ENHANCEMENT OF PRODUCT APPEAL

■ PARTS WITH LOW REPAIR COST

025BO23Y

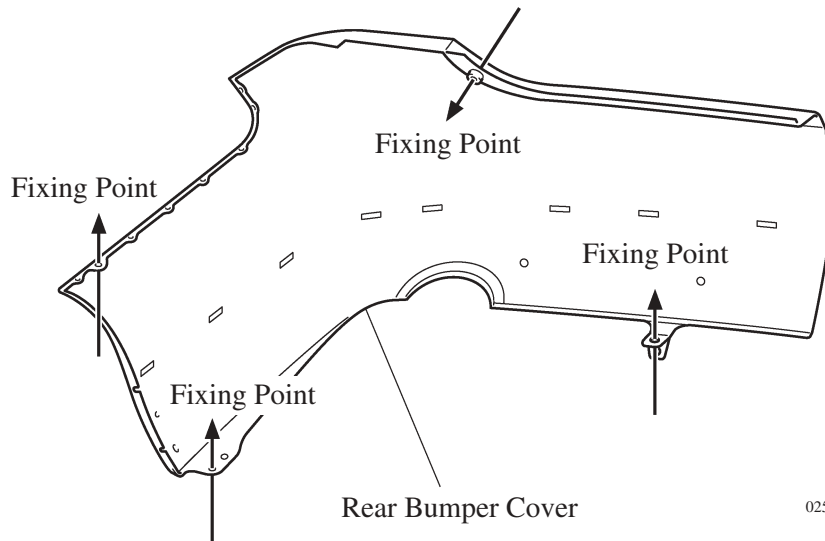
- The plating portion of the front grille of XLE grade models has been redesigned as an individual part. As a result, replacing only damaged parts is possible, reducing repair costs.
